Subject: Response to NRC Questions  
Comanche Peak Steam Electric Station  
Independent Assessment Program - Phases 1 and 2  
Texas Utilities Generating Company  
Job No. 83090

# Communications Report

Project: Comanche Peak Steam Electric Station  
Independent Assessment Program - Phases 1 and 2

## GENERAL NOTES TO PIPE SUPPORT CHECKLISTS

Weld Detail

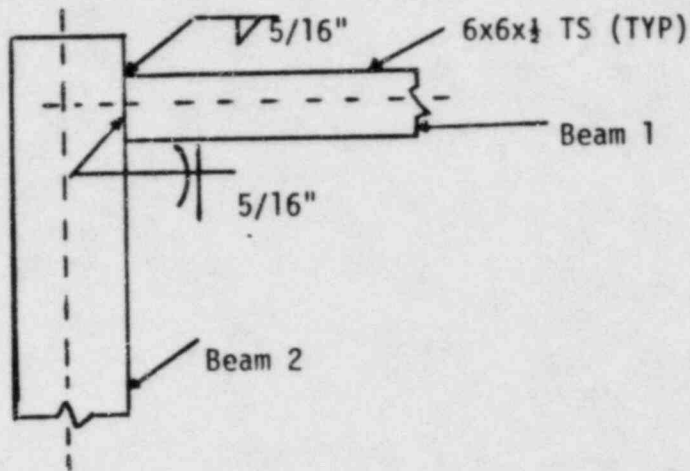
In certain connections, Cygna noted the use of 3-sided (see sketch) welds used to transfer the loads from one member to another. In most instances, the designer did not transfer the loads from the center of gravity of the beam (Point A) to the center of gravity of the weld (Point B). It is TUGCO's position that the designers use engineering judgment in determining if the effect will significantly impact design. That is, if the stress levels are low, the designer does not transfer the loads. For Cygna's assessment, see Observation PS-05.

#### 5. Use of .6Fy for U-Bolts

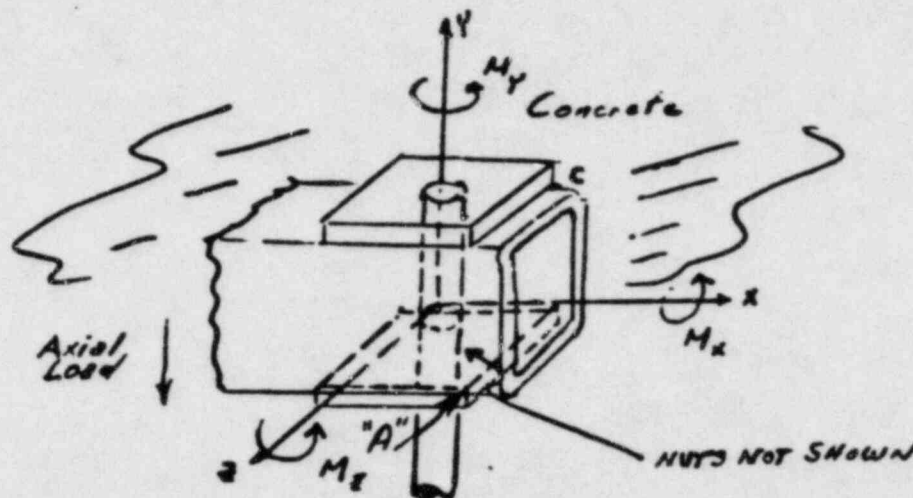
In designing the larger, non-standard U-bolts (i.e., 2-3/4" diameter rods, 2-1/4" diameter rods), the pipe support organizations have used an allowable tensile stress of .6Fy; actual bolt stresses were based on the tensile area of the threaded region. This conforms with the ASME Code Section III, Appendix XVII, Paragraph XVII-2211. In order to provide further justification for this procedure, ITT Grinnell performed a test program for 1/2" diameter and 1" diameter U-bolts (Reference Attachment to TUGCO letter dated May 2, 1984). Based on the results of those tests, ITT has shown quite clearly that .6Fy is an acceptable tensile stress allowable for U-bolts.
